WPB COLLIERY

COMMENTS ON INFORMATION GIVEN - MARCH 2012

Figure 1: Conceptual layout for pollution control collection channels and pollution control dams

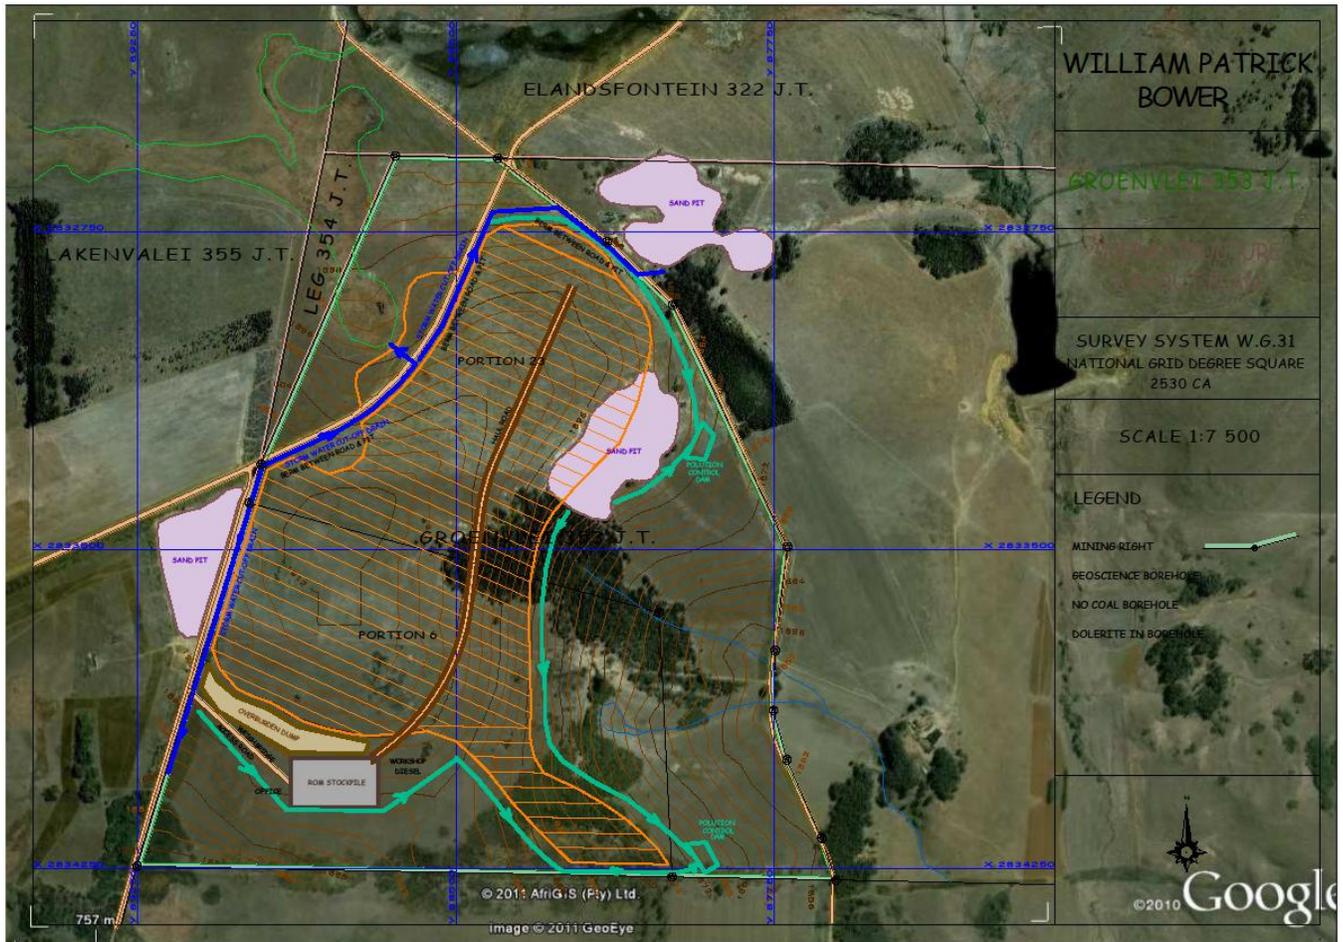
Figure 1 shows the conceptual layout for the pollution control collection channels and pollution control dams. My comments in previous correspondence are valid showing that insufficient thought went into laying out the pollution control system for the proposed mine. Some of the collection drains show water flowing uphill.

Figure 2: Recommended pollution control drainage channels and dams

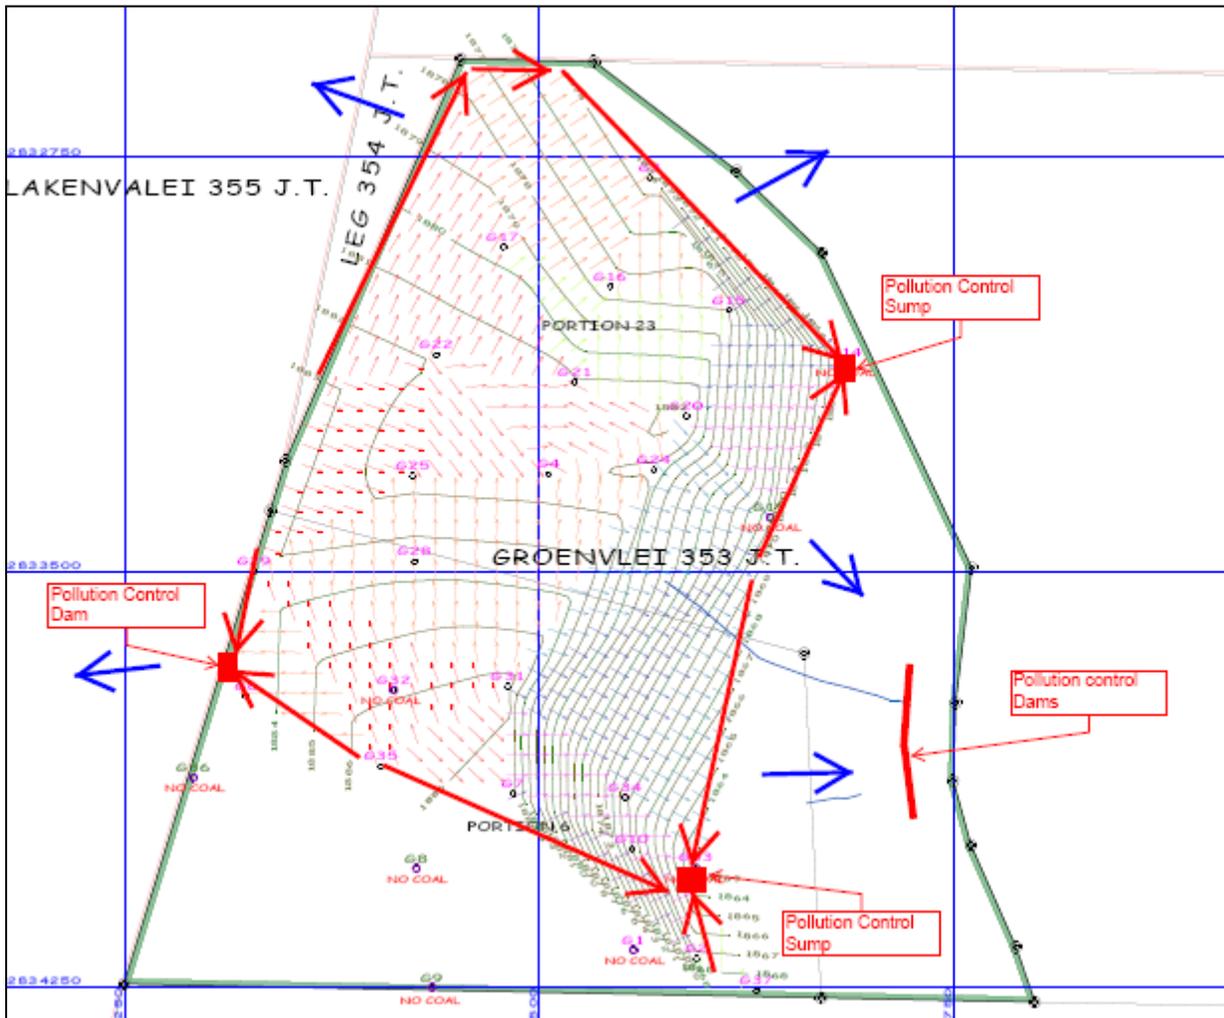
In the absence of a mining cut layout plan, I have used the #1 seam floor contour plans and water flow paths to compile Figure 2 which shows the recommended pollution control drainage channels and dams based on the floor contours and water paths submitted.

With reference to Figure 2 the following points are made:

1. No water will be accumulated in the post-mining pit which is contrary to what is stated in the documents submitted. All acid/contaminated water will flow out of the spoils and into the river system, with the dominant flow being to the south-east along the already contaminated water path.

2. Recommended polluted water collection drains are shown by the red arrows. It must be noted that these drains may have to be modified when superimposing the mining cut plan, seam contour plan and surface topography.
3. The location of collection sumps is shown as red squares which will collect the polluted water and direct this to a main pollution control dam situated in the drainage path flowing to the south-east.
4. The recommended position of the pollution control dam will need to be investigated to ensure that its construction will intercept all of the polluted water emanating from the workings.
5. In view of the fact that all of the acid water generated will flow out of the pit, the size of the pollution control dam will need to be correctly sized to ensure that it can contain the water in seasons of high rainfall.
